Product Change Notification

PCN-PCC-1282-2018

Business Unit	Product Line Code	Type of Change	Action	Date of Issue
PCC - PCB Connectors	AAA	Product Change Notification	Notify Distributors and Field	2/21/2018

Description for Product Change Notification

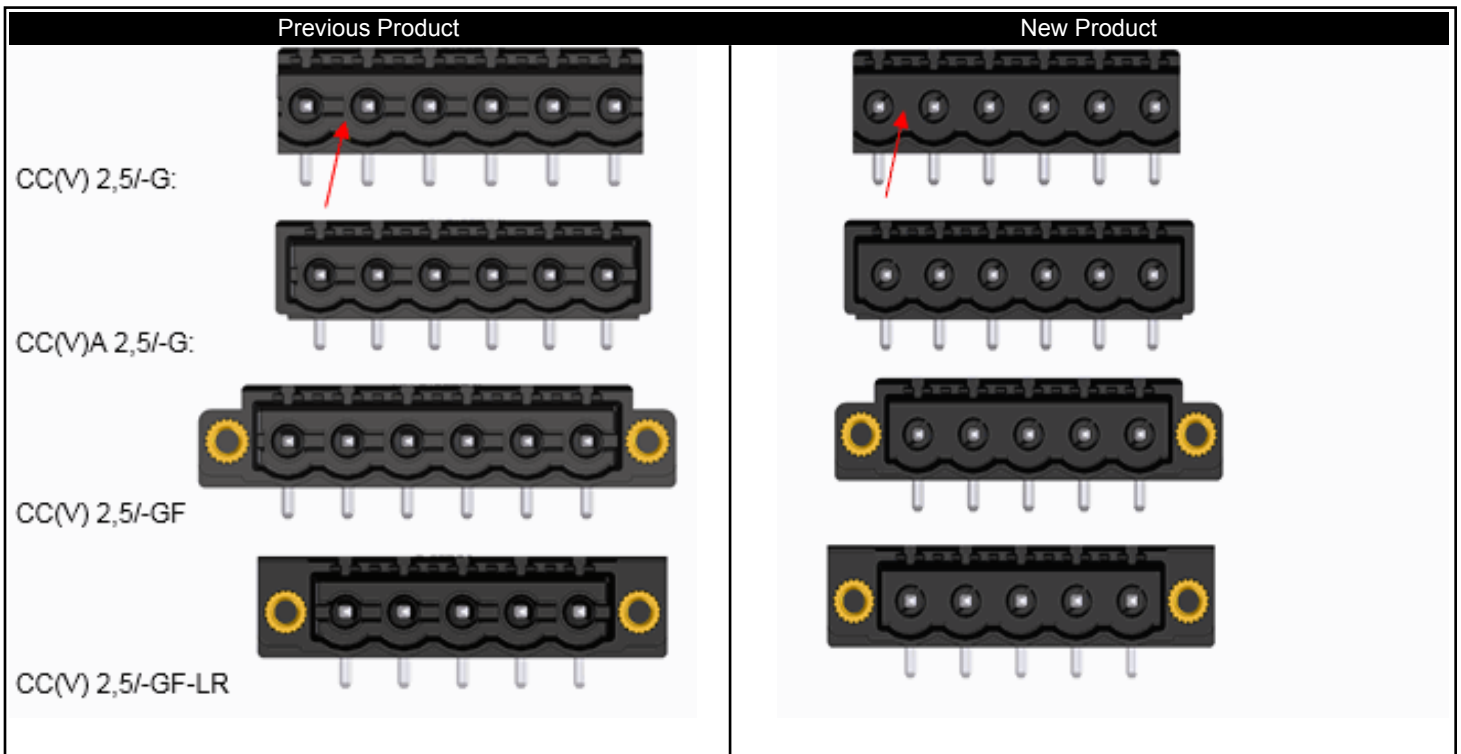
To optimize the production process, and within the scope of tool adaptations, the inner contour of the 2-12 position plastic housing will be changed. This change has no effect to the outer dimensions of the connector or the drilling pattern. Also the technical specifications are not affected by this change. During the changeover phase both variants will be delivered in parallel depending on the stock. New versions will be identified by the change in version code as noted on the attached spreadsheet. New versions are expected to begin shipping June 1, 2018.
